FLORIDA GATEWAY COLLEGE

Addendum Two

ITB #21-3-01 – Olustee Armory Building

This Addendum has been issued to address vendor questions.

Revision Schedule		
Revision Number	Revision Description	Revision Date
0	ISSUED FOR CONSTRUCTION	8/24/20

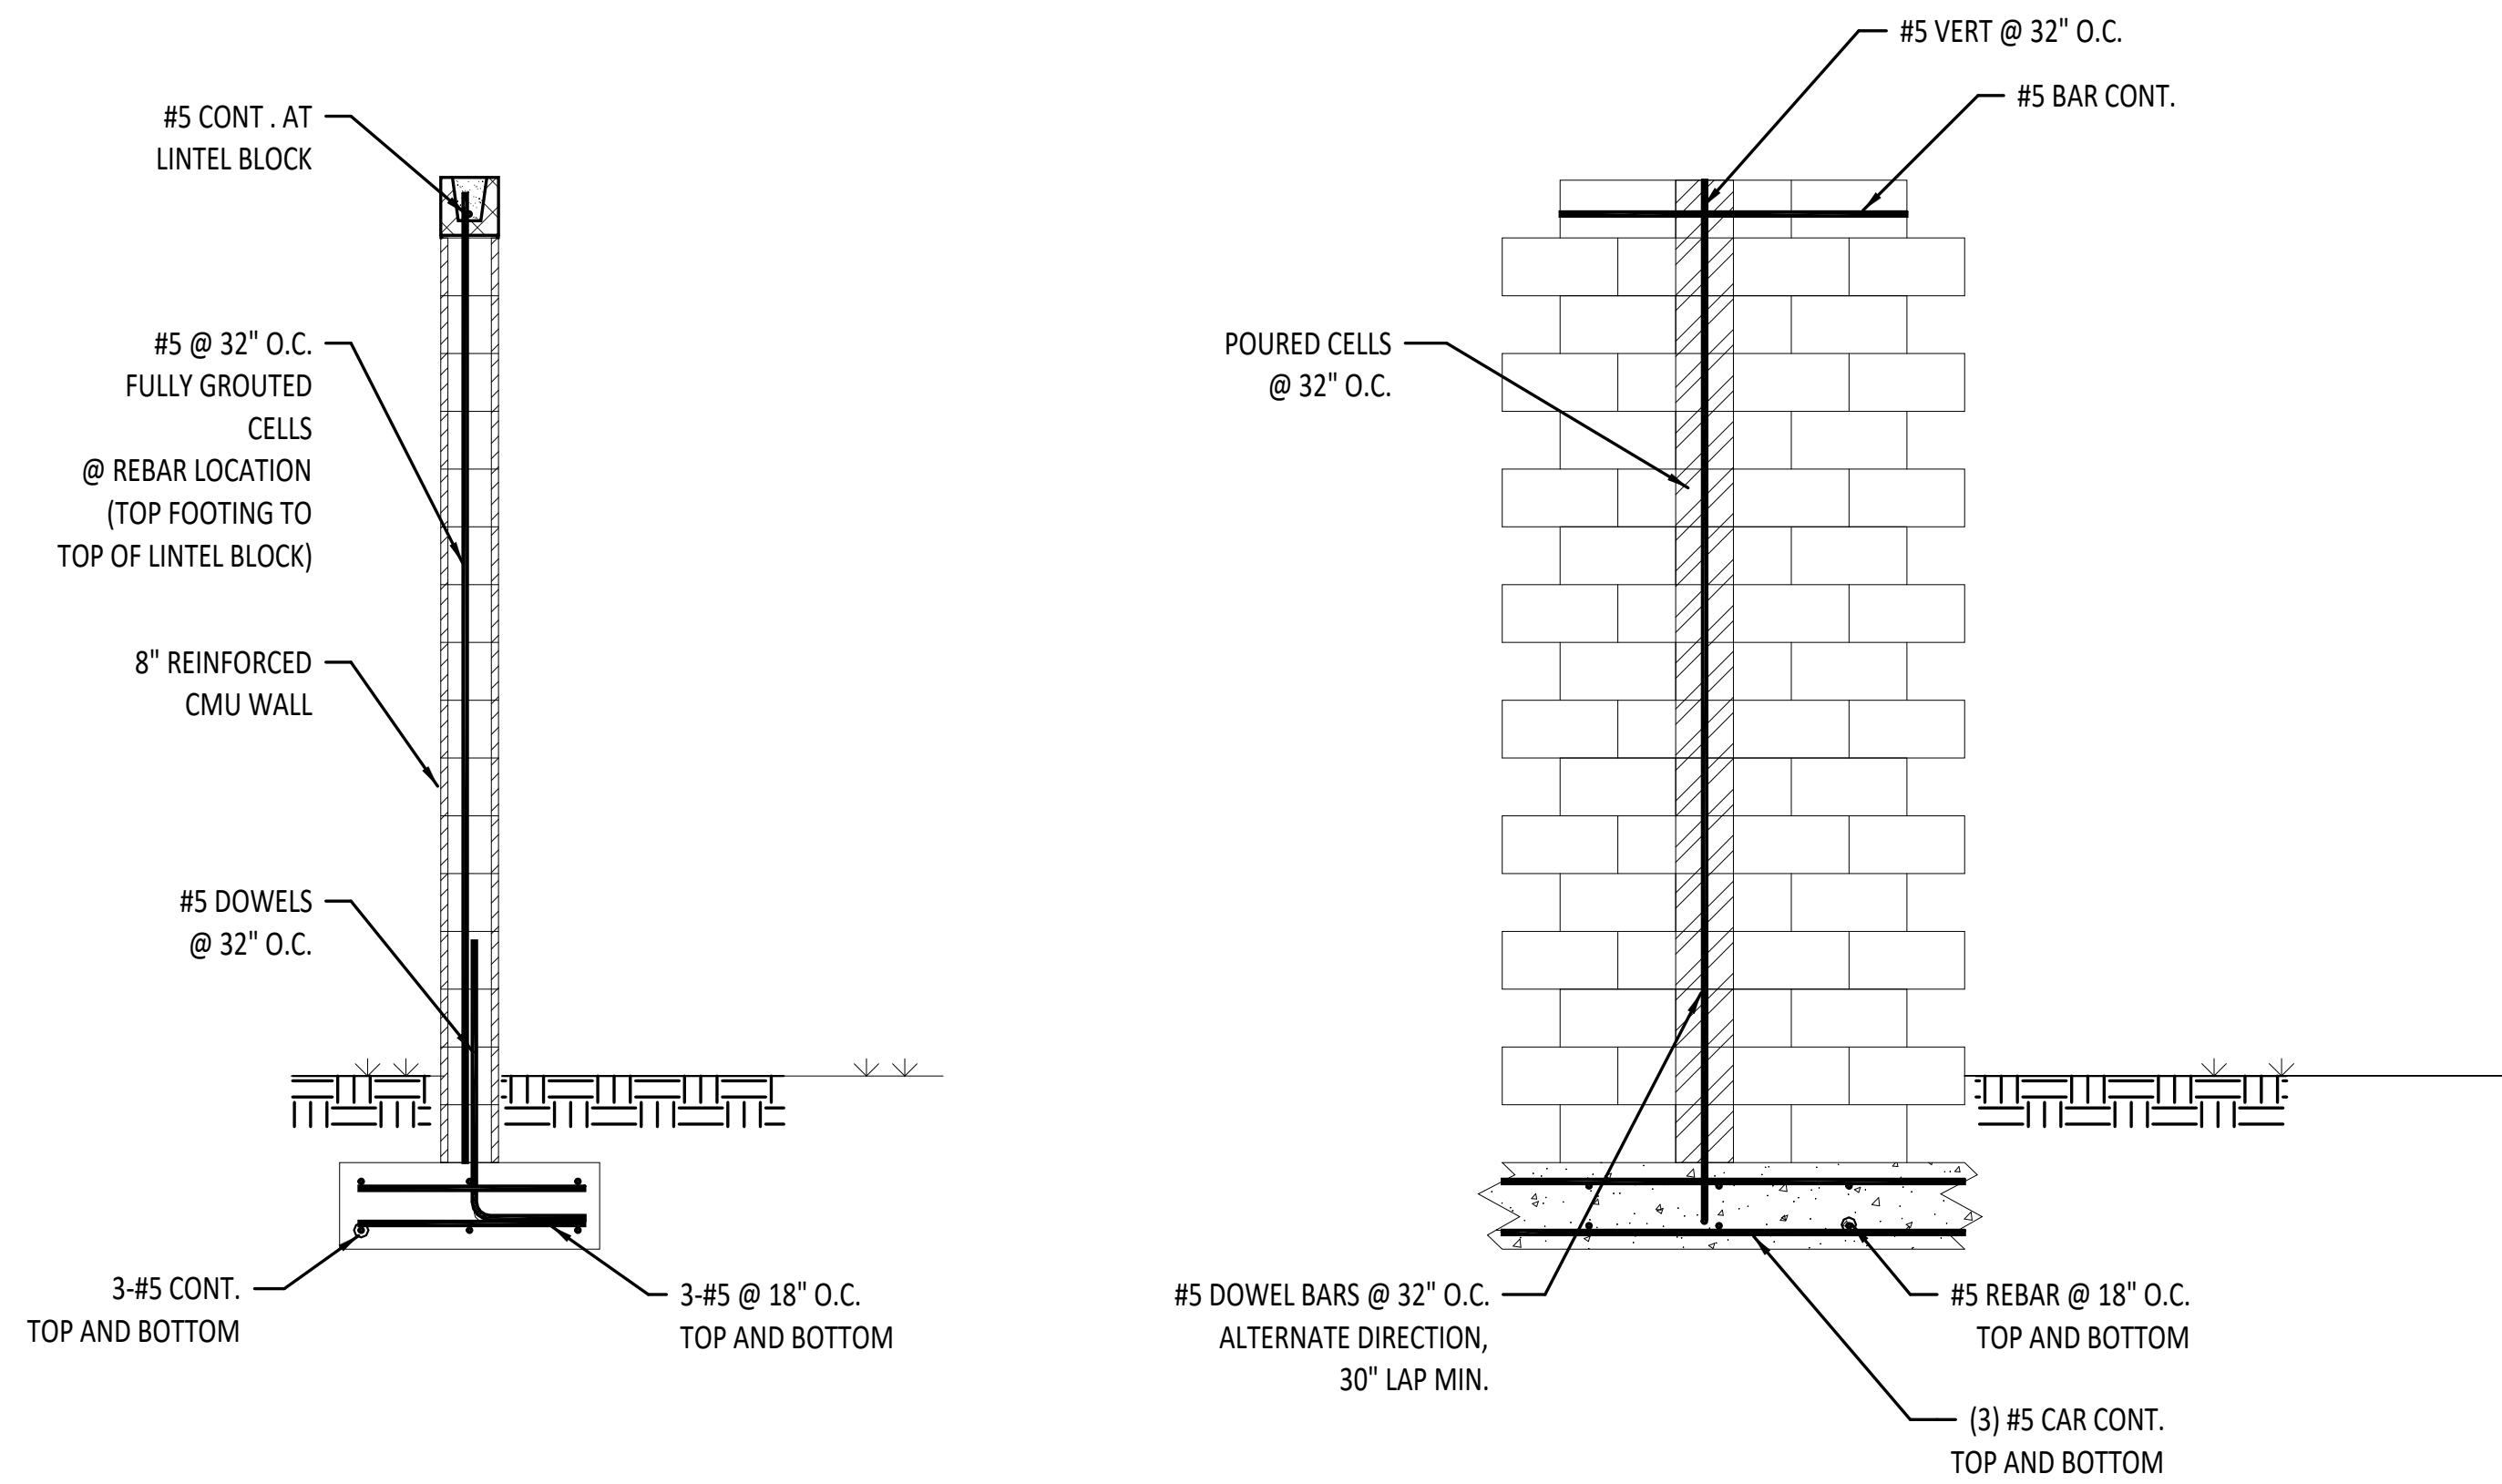
Question 1: What is the structural design of the base of the masonry wall?

Answer: See detail 2 of the attached block wall drawing.

GUN RANGE SITE PLAN
CDL TRAINING COURSE
 EDA INVESTMENT NO. 04-79-07399, ----

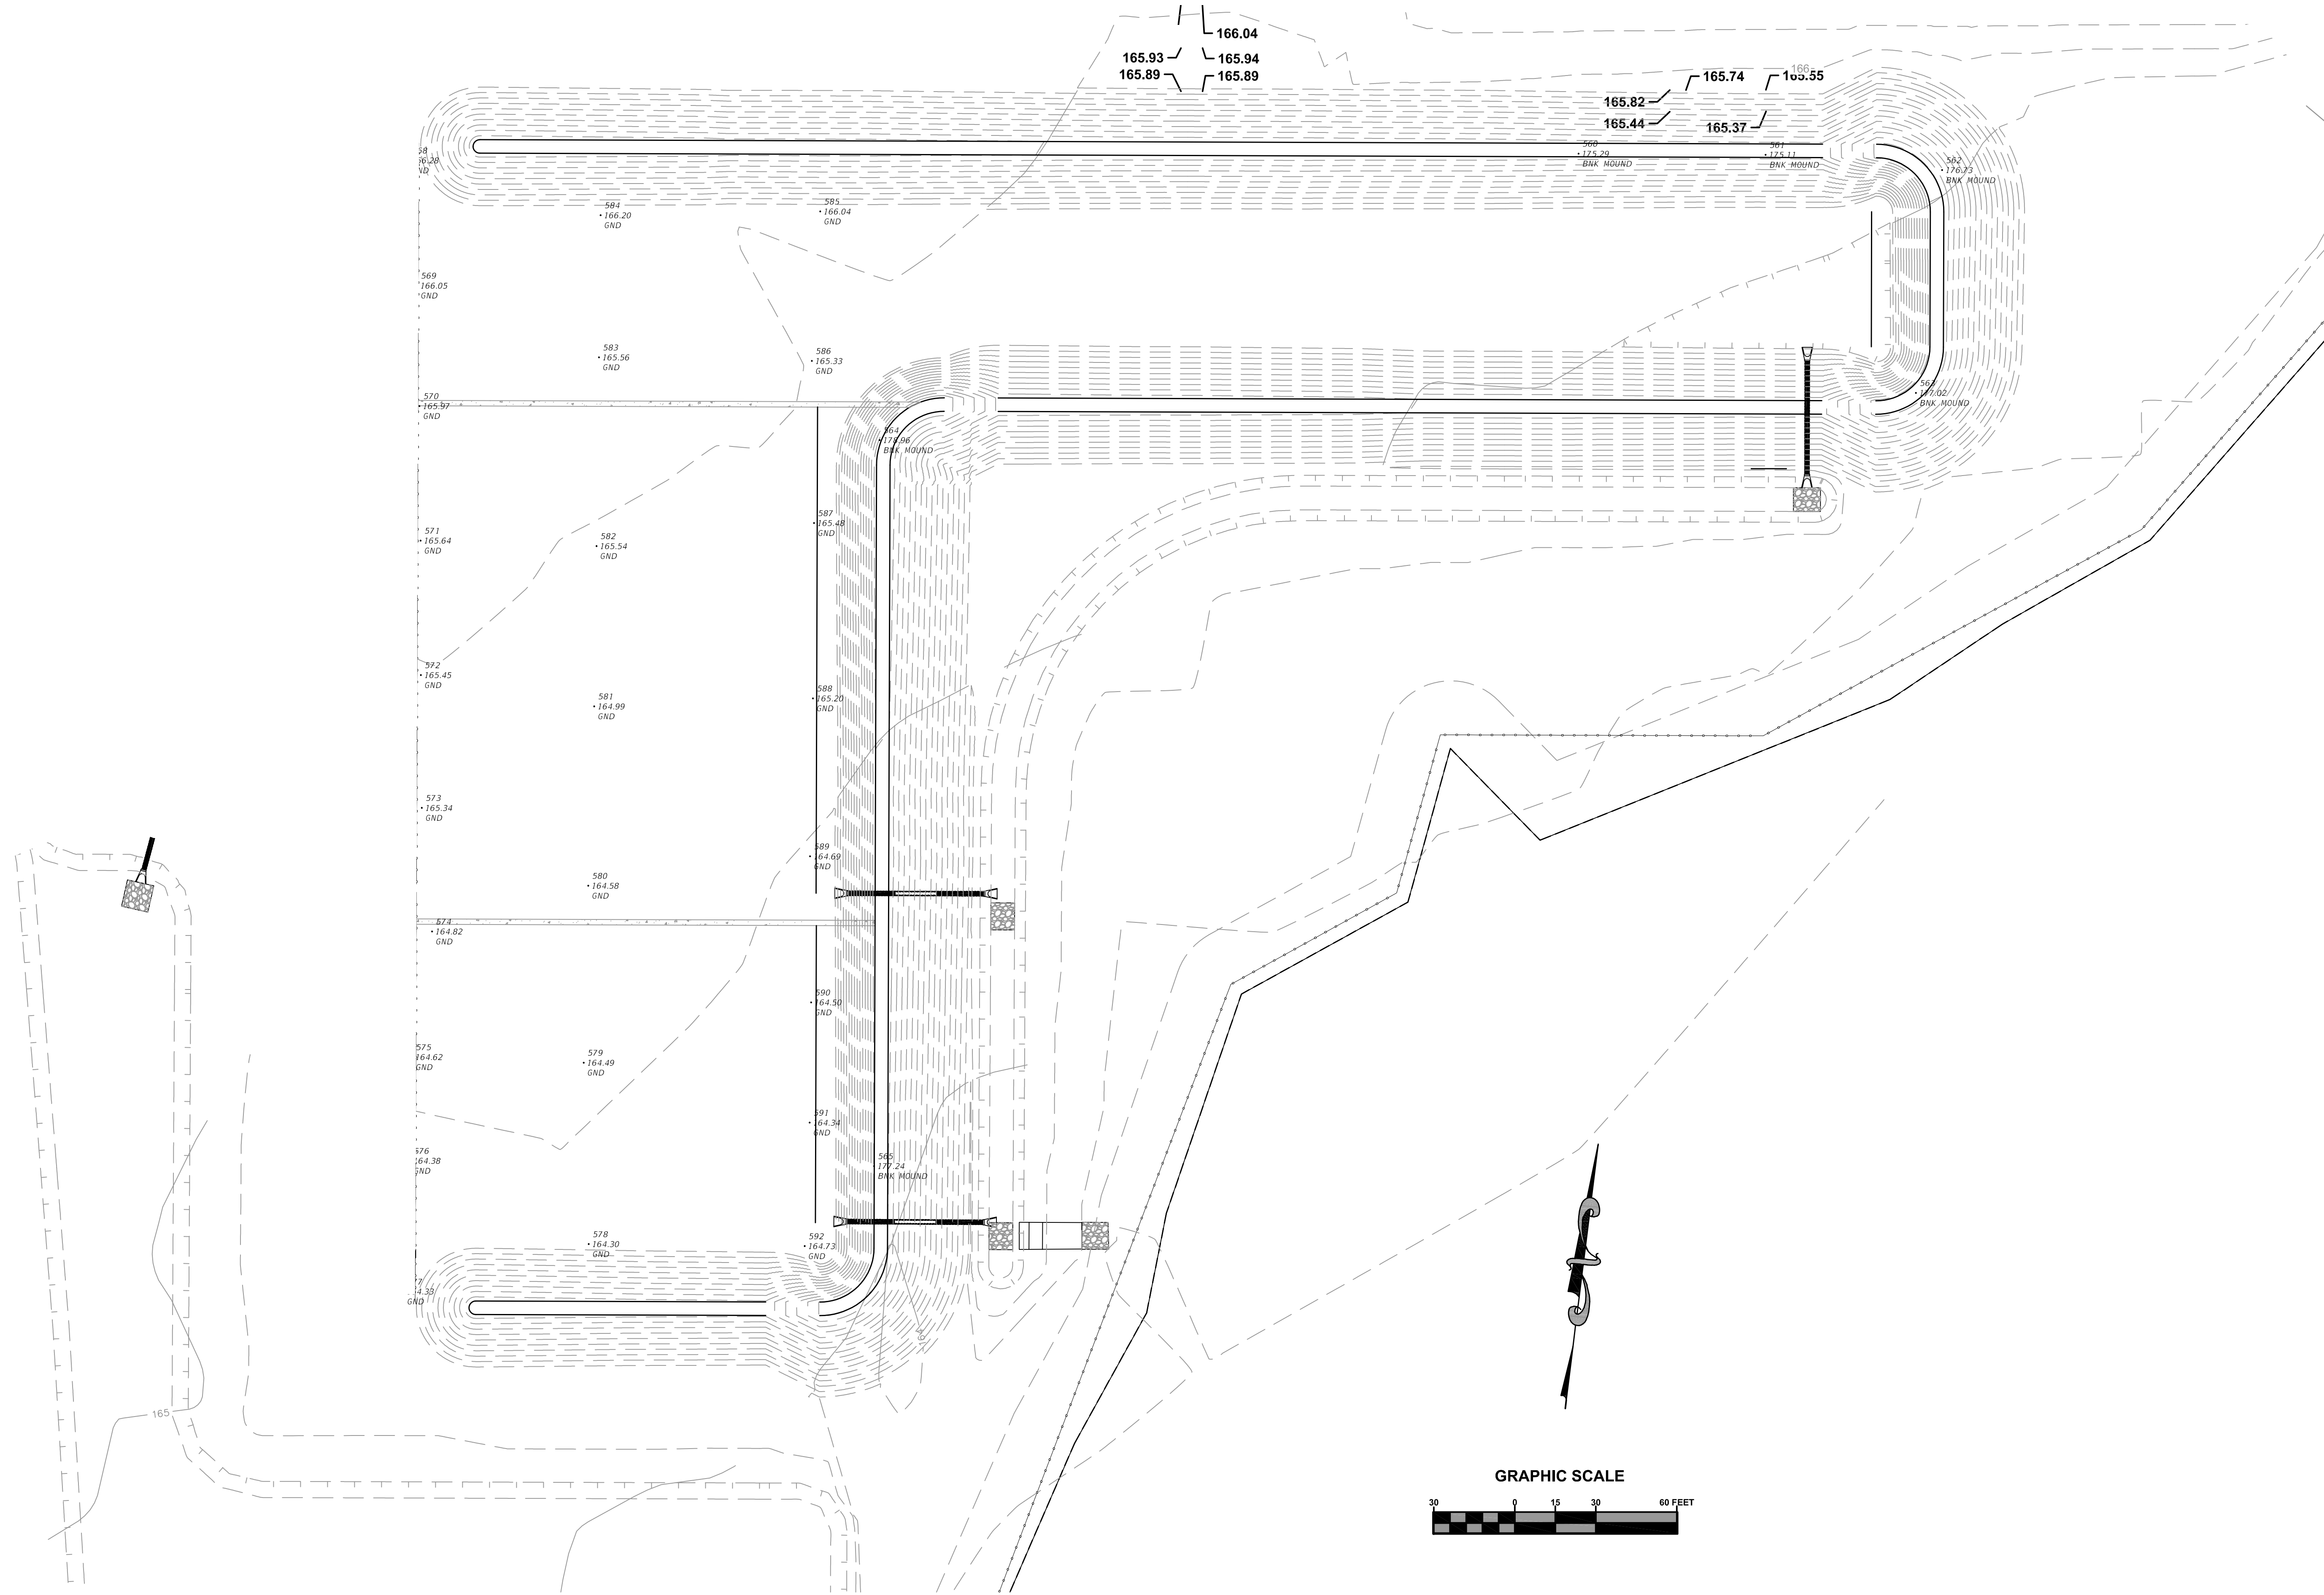
Question 2: What topographic information will be shared with the contractors to handle the terrain at the base of the wall?

Answer: See the attached gun range topographic drawing. Minimum of 12" of earth cover is required above the footer at the lowest area of the site, which is the eastern area of the walls. That would put the top of the north wall around 175.33' and the top of the south wall around 174.83'.
